**ESENCIA PORTABLES PHASE 2 PROJECT (re-bid)
Bid No. 2324-11**

**ADDENDUM NO. 1
June 18, 2024**

Subject: **ESENCIA K-8 SCHOOL
MODULAR CLASSROOMS**
Capistrano Unified School District

ADDENDUM No. 3

ITEM 03: SHEET E-1.1 ELECTRICAL SITE PLAN

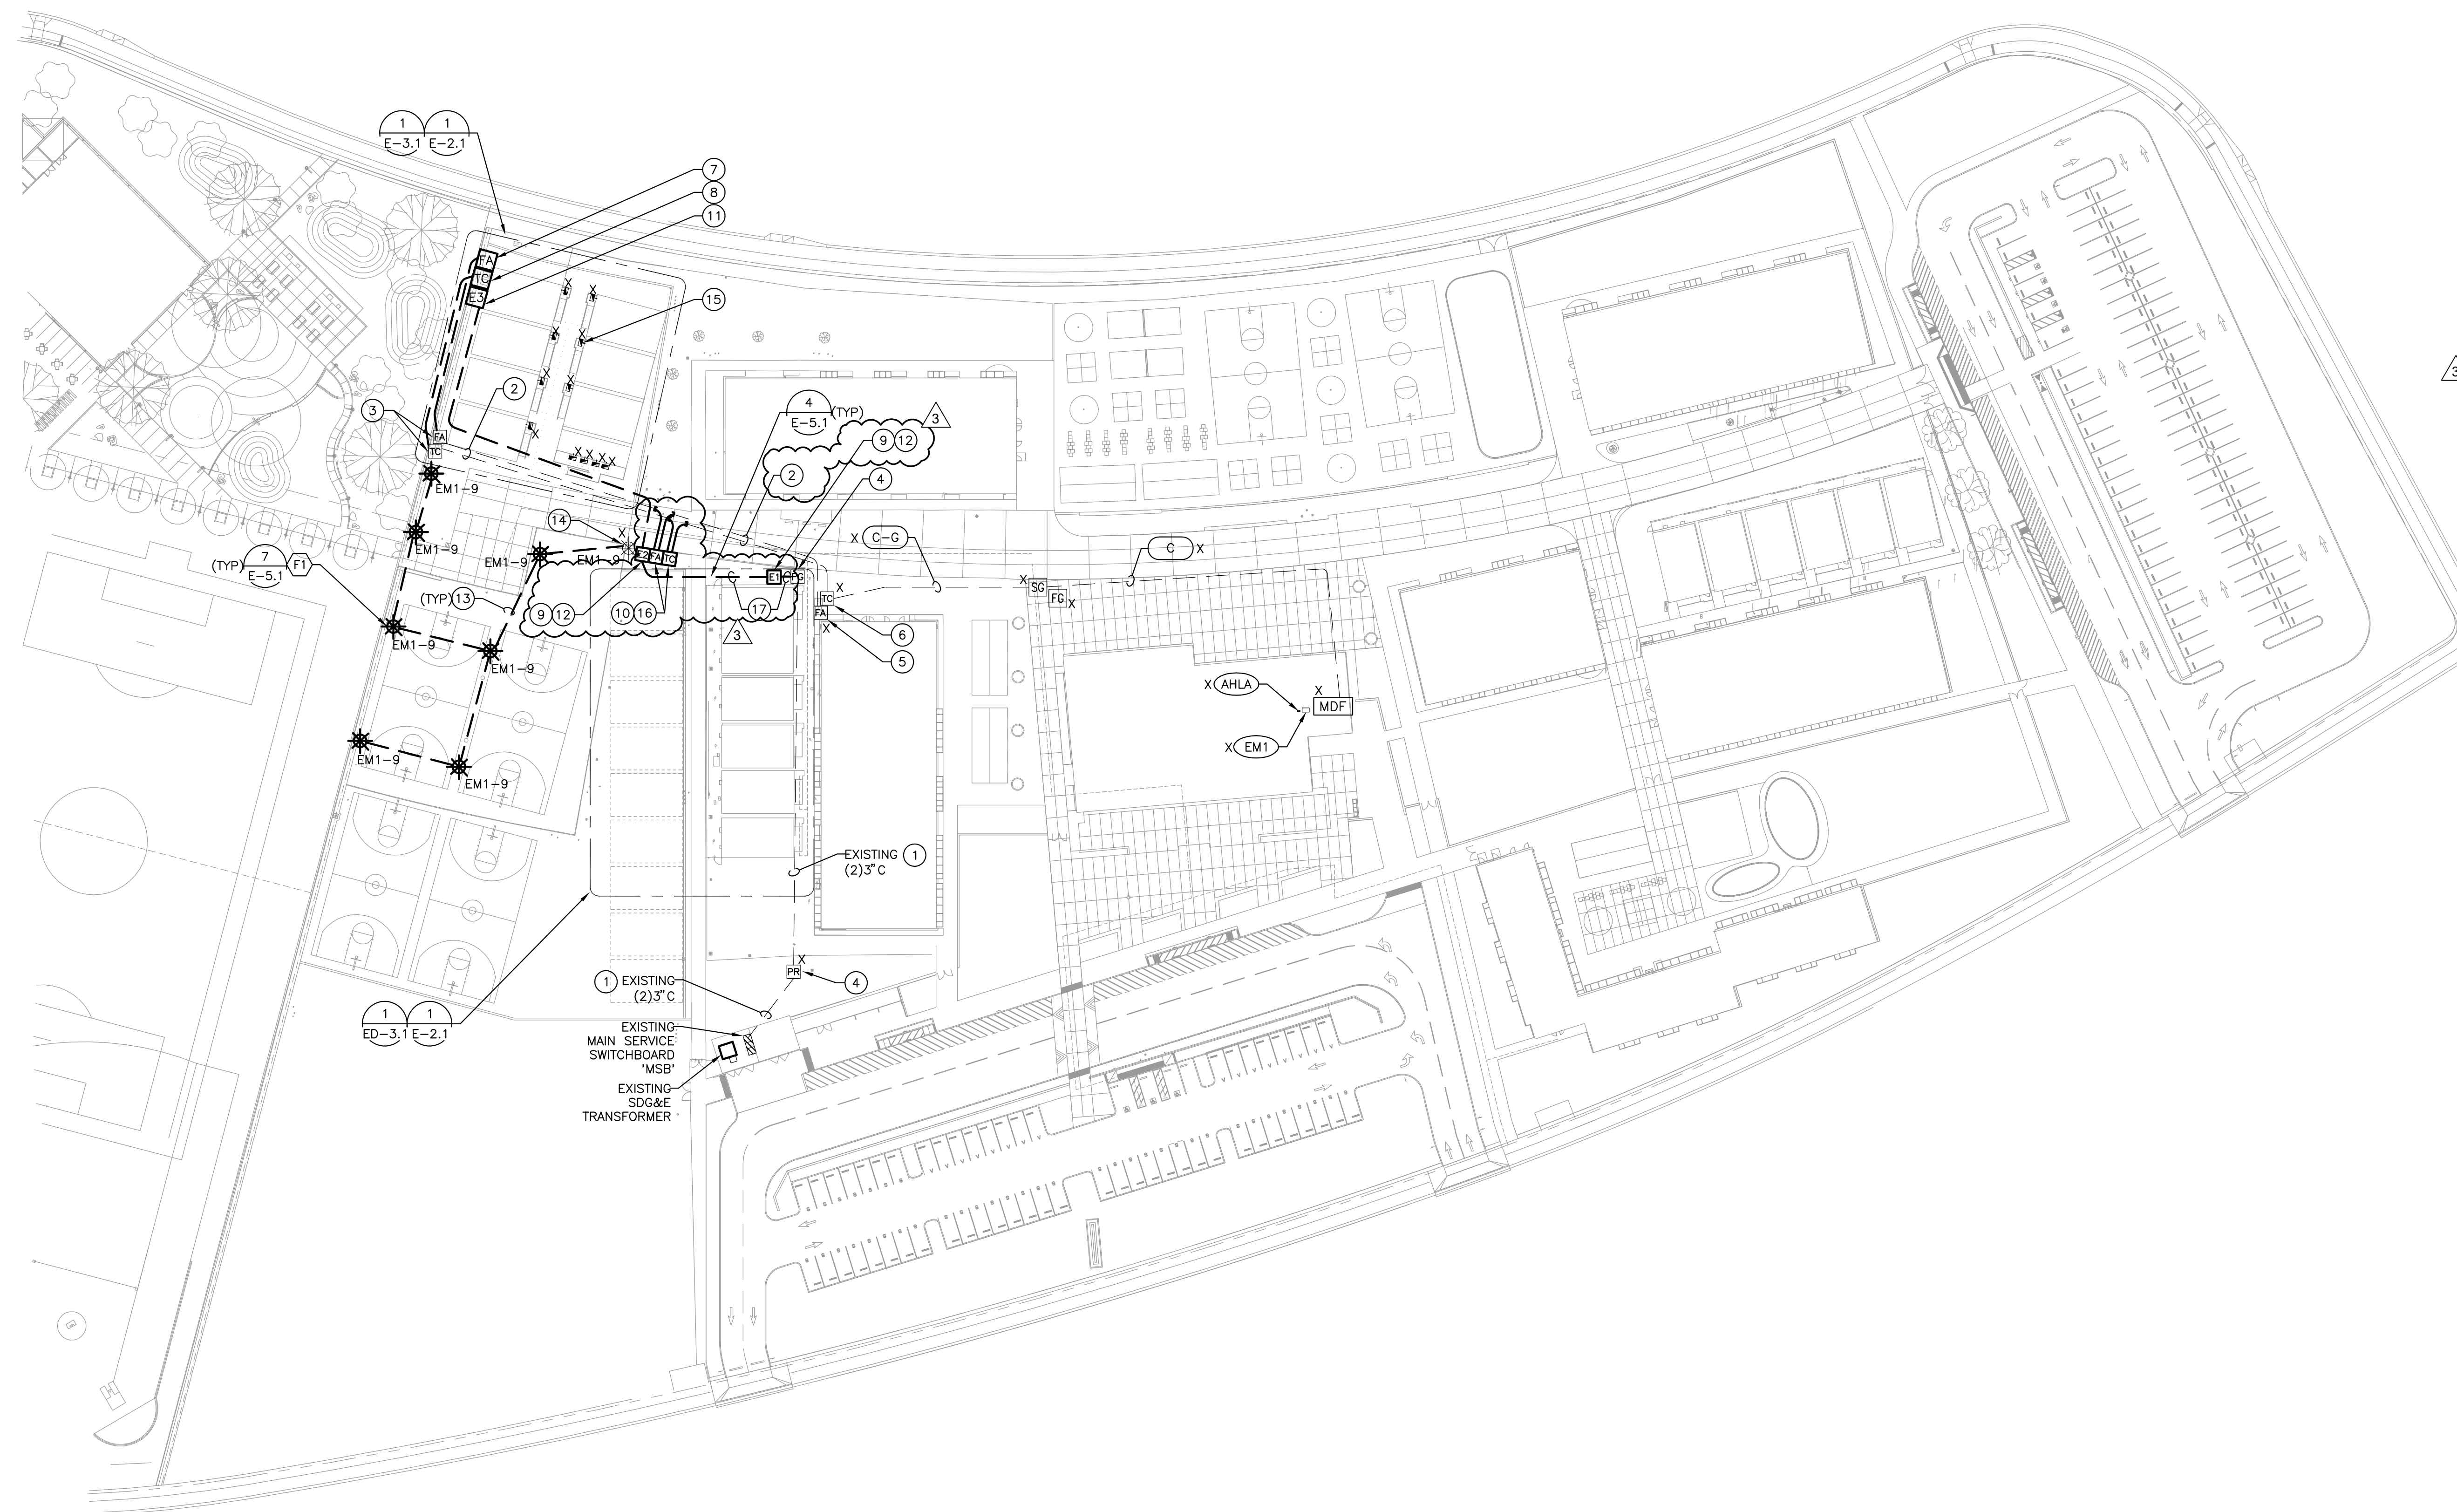
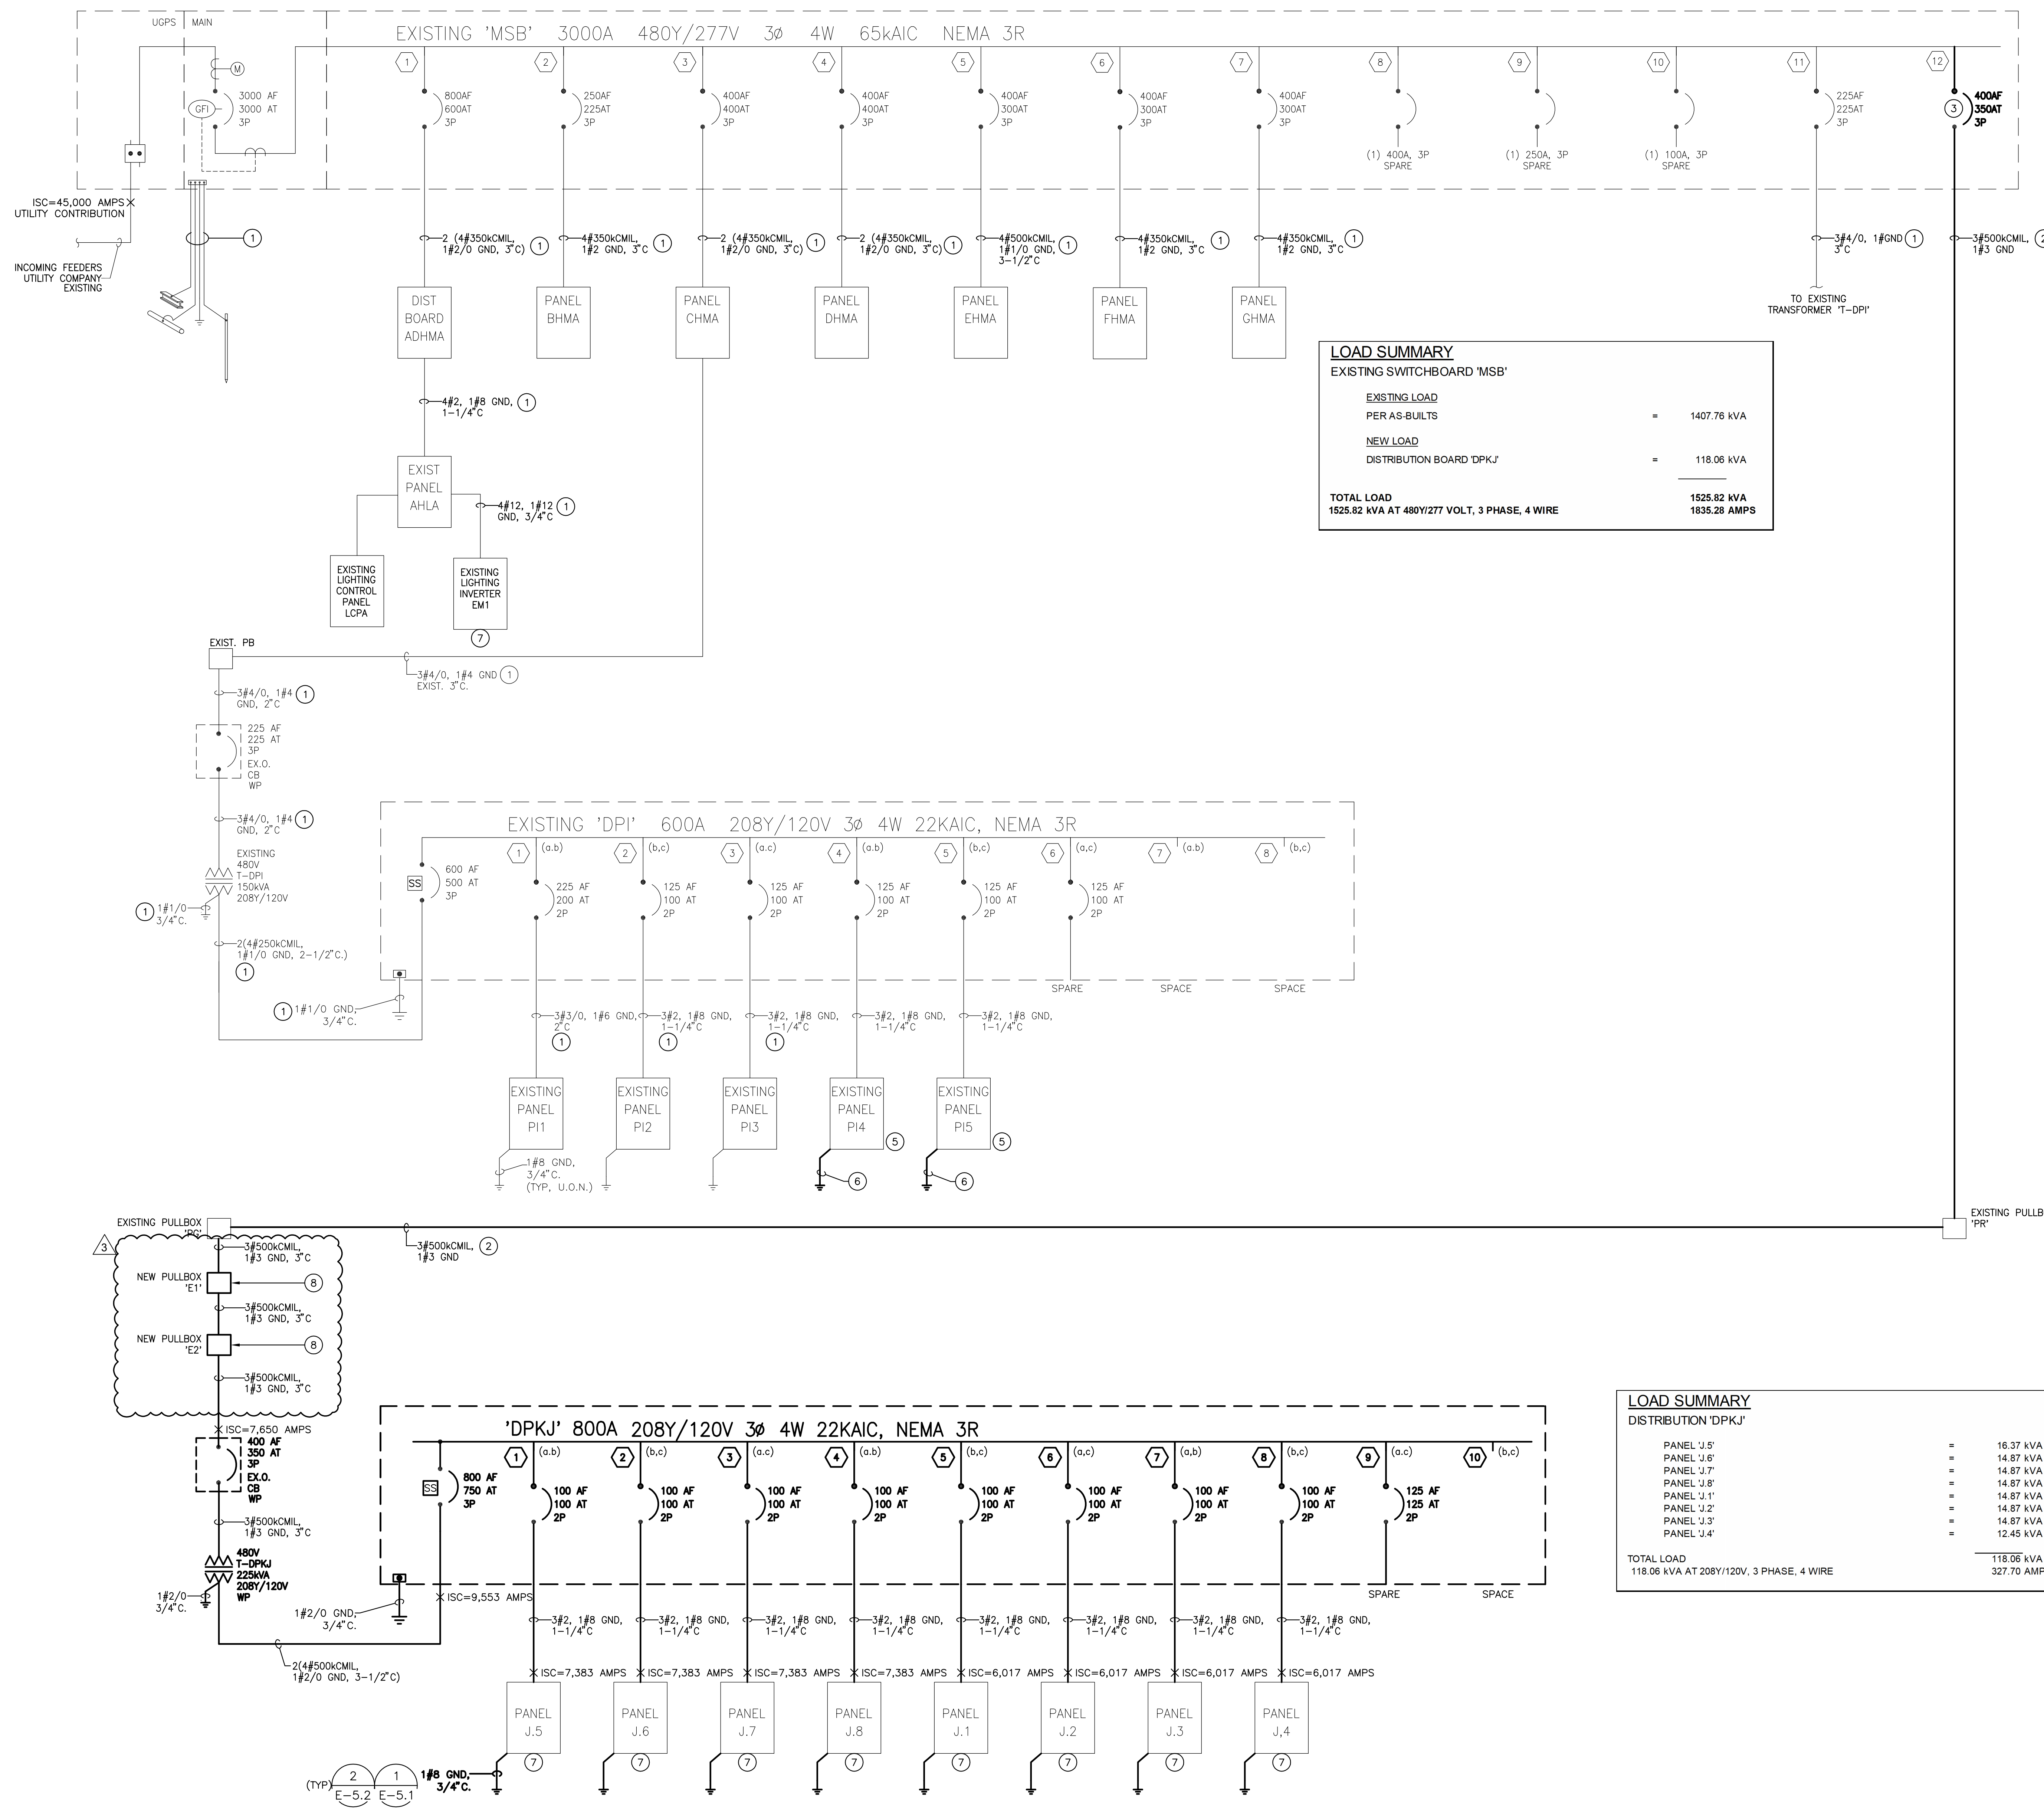
- A. At Keynotes, add note #17 in it's entirety as shown.
- B. At Electrical Site Plan, revise connections to existing electrical services and associated pathways to new equipment locations.

- PROVIDE NEW UNDERGROUND PULL BOX FOR TELECOM AND FIRE ALARM.
- INTERCEPT AND EXTEND NEW (1) 3" CONDUITS, (1) 3" SPARE AND (1) 2" CONDUIT SPARE. SEE SINGLE LINE DIAGRAM FOR CONDUCTORS.
